This document is including all the changes proposed, by means of informal documents or during the GRE 85th session, to the GTB proposal on “Driver assistance projection”.

The changes proposed here below in respect to the official GTB proposal (Document GRE/2021/18) are highlighted in green.

A. New Supplement to the 06, 07 and 08 series of amendments to UN Regulation No. 48

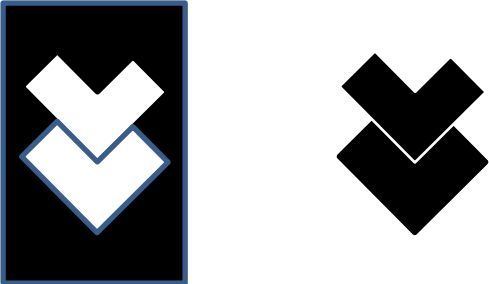
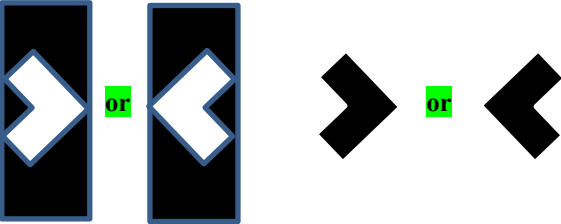
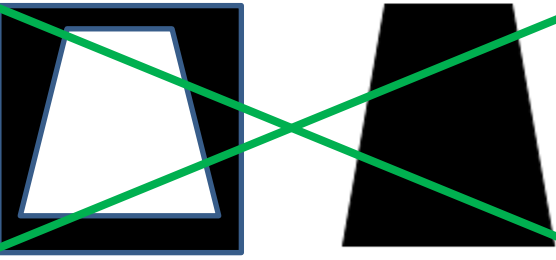
Add a new paragraph 2.8. in Annex 12; to read:

“2.8. For the test sections A, B, C and E in the table above the engineers conducting the tests shall evaluate Driver Assistance Projection if installed.”
